Planning Application Ref: BE/92/19/T

Location: Springfields, Chichester Road, Bersted, PO21 5EE

Description of works: Crown lift to 5m 1no. holm oak tree and reduce all side branches by 1.8m up to height of 6m to 1no. blue cedar tree

Comments on Application:

Figure 2 Positions of final cuts

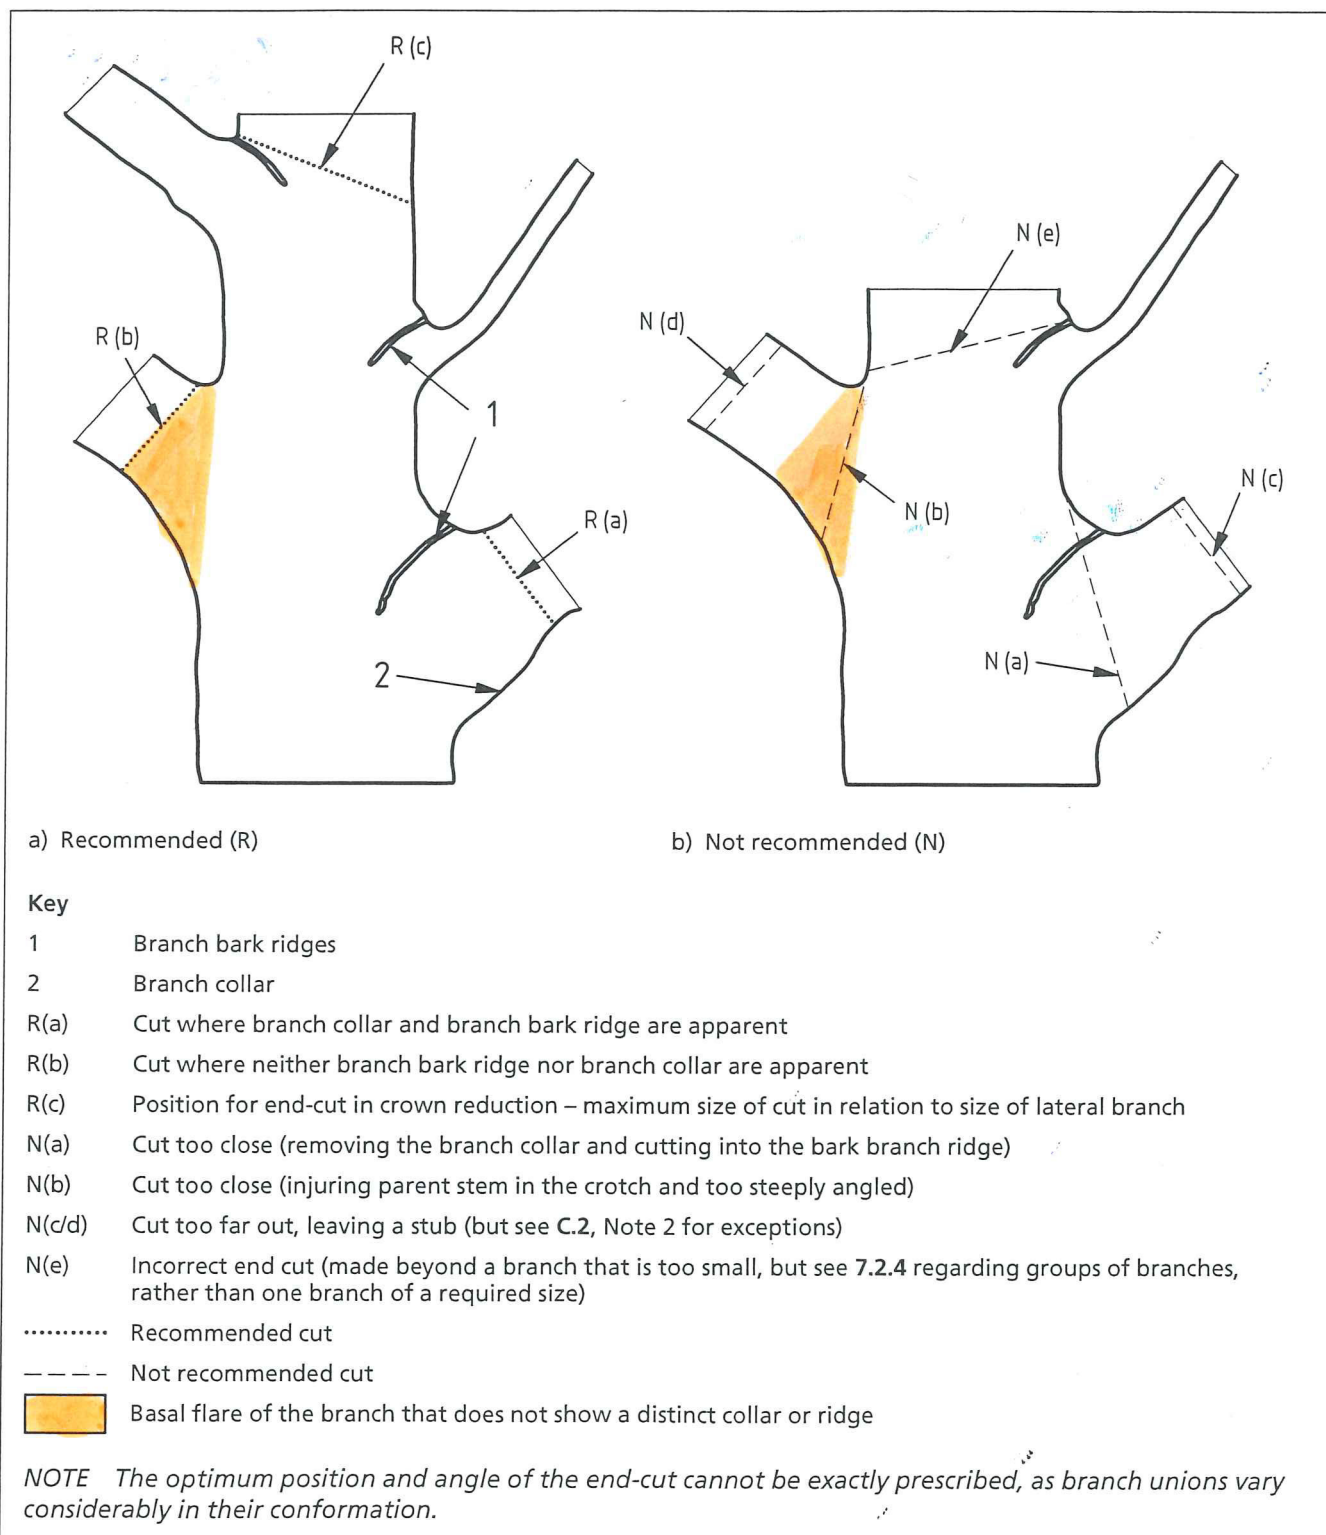
- Where whole branches are to be removed and final cuts made close to the trunk or branch union they are to be made as shown in Figure 2 of BS3998:2010
- Where branches are to be shortened back the final cuts are to be made at the correct angle shown in BS3998:2010 and adjacent to a live bud or lateral.
